Subject: Docket Number 50-184 license amendment request

10 CFR 50.59 EVALUATION		ECR No.:	1251
ECR/Experiment Title:	Operating the NBSR with small amounts of unclad fuel in primary system		
System:	Primary Cooling/Moderator	Date:	10/13/2022

ENGINEERING CHANGE NOTICE (ECN)		ECR No.:	1251
ECR Title:	Operating the NBSR with small amounts of unclad fuel in primary system		
System:	Primary Cooling System	Date:	9/29/2022

Potential Release of Fission Products from the NCNR Reactor During Startup Operations

Figure 1: Dose vs Distance Class B Stability

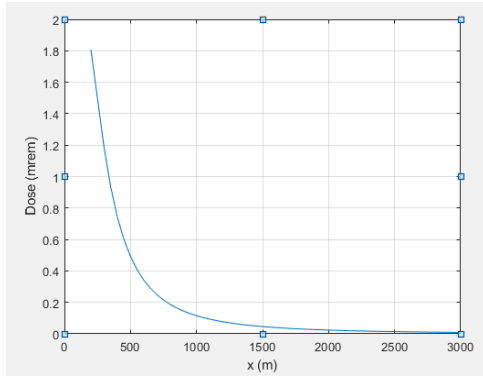
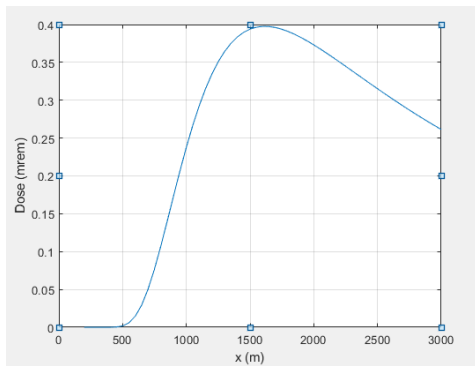
4. *HOTSPOT* - Possibly mention that release is assumed to be continuous and conservatively assumed that the wind blows in one direction throughout the day; moderately stable Class F could result in somewhat higher dose rate. Possibly mention that breathing rate is in accordance with Appendix B of Part 20; mention the vintage/year of the FGR-11/12 being used by the version of Hotspot.

Added text to clarify the assumptions in HOTSPOT and how they are conservative. Also mentioned that HOTSPOT in most cases used FGR-11/12. Although in cases where dose conversion factors don't exist for some isotopes, FGR-15 was used. Although it is true that F class can lead to higher dose rates, it is not correct in this case. The dose in this case is dominated by shorter lived isotopes. For class F, the maximum occurs at a much farther distance and thus isotopes decay before reaching that point. Thus, for longer lived isotopes F is more conservative but for shorter lived isotopes B is more conservative. Below are two figures comparing the dose rate from noble gases from this postulated release for Class B stability and Class F stability.
